# **Intel<sup>®</sup> Pentium<sup>®</sup> III Processor Specification Update**

Release Date: February 2002

Order Number: 244453-037

The Pentium<sup>®</sup> III processor may contain design defects or errors known as errata which may cause the product to deviate from published specifications. Current characterized errata are documented in this Specification Update.

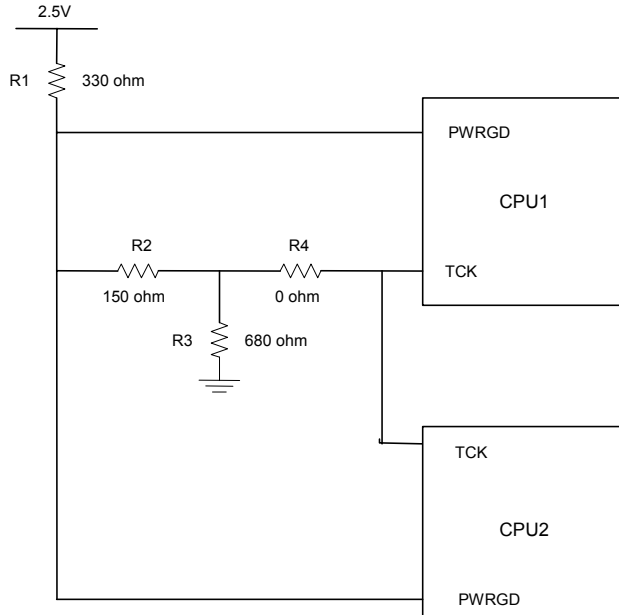
**Problem:** The internal control register bit responsible for operation of the Thermtrip circuit functionality may power up in a non-initialized state. As a result, THERMTRIP# may be incorrectly asserted during de-assertion of RESET# at nominal operating temperatures. When THERMTRIP# is asserted as a result of this erratum, the processor may shut down internally and stop execution but in few cases continue to execute.

**Implication:** This issue can lead to intermittent system power-on boot failures. The occurrence and repeatability of failures is system dependent, however all systems and processors are susceptible to failure. In addition, the processor may fail to stop execution during the event of a valid THERMTRIP# assertion resulting in the potential for permanent processor damage.

**Workaround:** To prevent the risk of power-on boot failures or catastrophic thermal failures, a platform workaround is required. The system must provide a rising edge on the TCK signal during the power-on sequence that meets all of the following requirements:

- Rising edge occurs after Vcc\_core is valid and stable
- Rising edge occurs before or at the de-assertion of RESET#
- Rising edge occurs after all Vref input signals are at valid voltage levels
- TCK input meets the Vih min and max spec as mentioned in EMTS

**Figure 1: Noise Estimation**

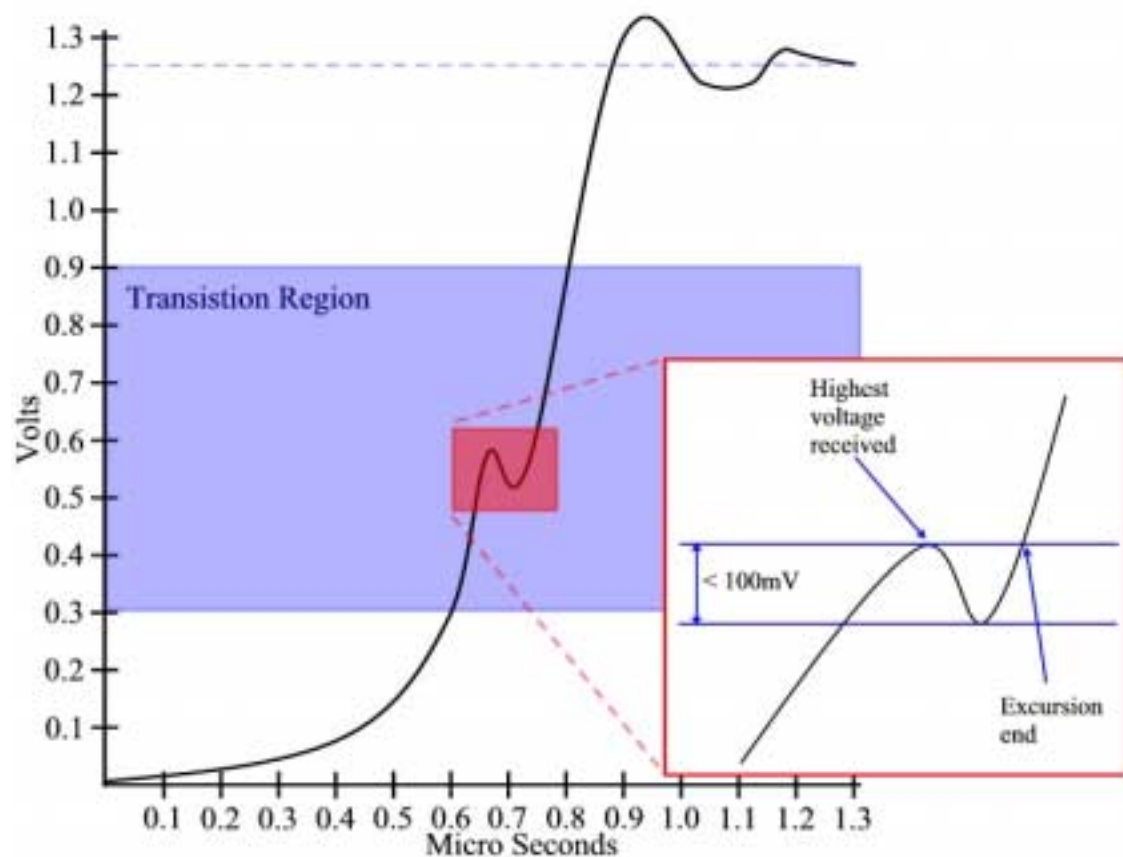
The signal quality of the VTT\_PWRGD signal is critical to the correct operation of the processor. Every effort should be made to ensure this signal is monotonic in the transition region. If noise or glitches are present on this signal, it must be kept to less than 100mV of a voltage drop from the highest voltage level received to that point. This glitch must remain less than 100mV until the excursion ends by the voltage returning to the highest voltage previously received. Please see Figure 1 for an example graph of this situation and requirements.

This change will be incorporated into the next revision of the Datasheet.
